**Re: Comments of Sterigenics U.S., LLC on NESHAP Proposed Rule,
Docket ID No. EPA-HQ-OAR-2019-0178**

**Comments of Sterigenics U.S., LLC on the U.S.
Environmental Protection Agency's National
Emission Standards for Hazardous Air Pollutants:
Ethylene Oxide Emissions Standards for
Sterilization Facilities Residual Risk and
Technology Review Proposed Rule**

Figure 1 shows the relationship between the inlet and outlet concentration for each of the proposed percent emission reduction standards contained in the proposed NESHAP:

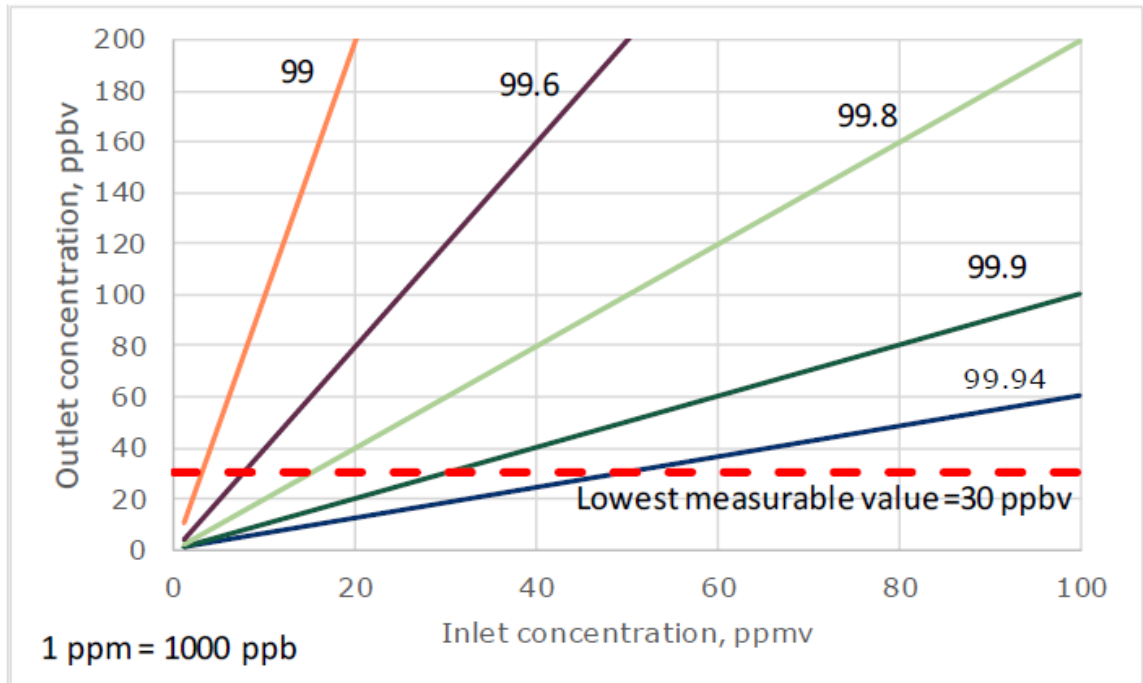
In a performance test, the percent of emission reduction is calculated as the percent reduction in mass of EtO, comparing the pre-control mass to the post-control mass. Assuming the airflow is the same at the control device input and output, the percent emission reduction is also equal to the percent reduction in concentration of EtO.

As the figure shows, at any given percent reduction, the lower the inlet concentration to a control device, the lower the outlet concentration will be. But if the lowest practicably measured concentration is 30 ppbv, then a facility with an *inlet* concentration that is too low will be unable to show the required percent reduction, even if the control device is providing that level of reduction, because the monitoring approach will be unable to distinguish the true outlet concentration from 30 ppbv.

Figure 2 organizes the same information to show the minimum inlet concentration required to be able to show EPA's various percent emission reduction requirements:

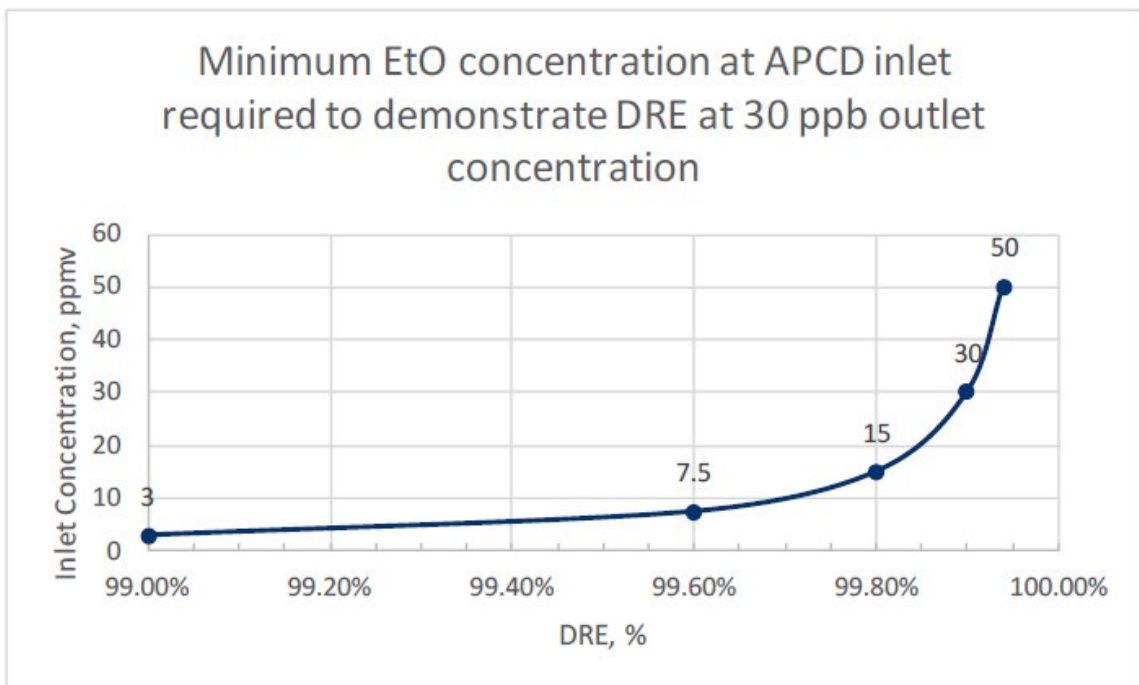
This figure shows that, to demonstrate a percent emission reduction of 99.6 percent, a facility must have an inlet concentration of at least 7.5 ppmv. To demonstrate a percent emission reduction of 99.94 percent, a facility must have an inlet concentration of at least 50 ppm.

This is particularly problematic for ARVs. EPA has proposed that ARVs demonstrate 99.9 percent emission reduction for new facilities using at least 10 tpy of EtO and 99.6 percent reduction for existing facilities of that size. As Figure 2 shows, new facilities would have to have pre-control aeration room concentrations of at least 30 ppmv to make this demonstration, and existing facilities would have to have pre-control concentrations of 7.5 ppmv or greater.

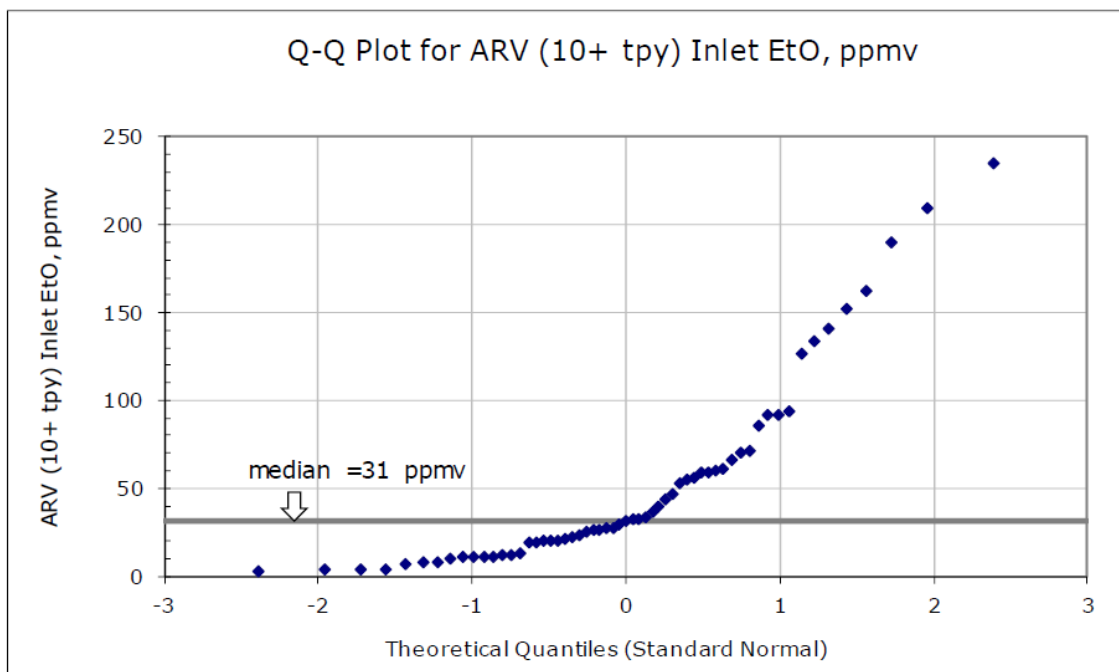
Figure 3 shows inlet concentrations for ARVs of this size class listed in EPA’s compilation of test data,⁶⁴ presented as a normal quantiles plot. (One high outlier value of 794 ppmv is not shown for clarity.) This type of plot represents the distribution of the data: the median value occurs at a value of zero on the x-axis, with lower values to the left of that point and higher values to the right.

The median value occurs at 31 ppmv, which is barely sufficient to demonstrate the proposed percent emission reduction for a new facility. Nearly half (47 percent) of the aeration room inlet concentrations that EPA compiled are less than 30 ppmv, so for those facilities, it would not be possible to demonstrate compliance with this standard, even if the actual percent emission reduction were sufficient.
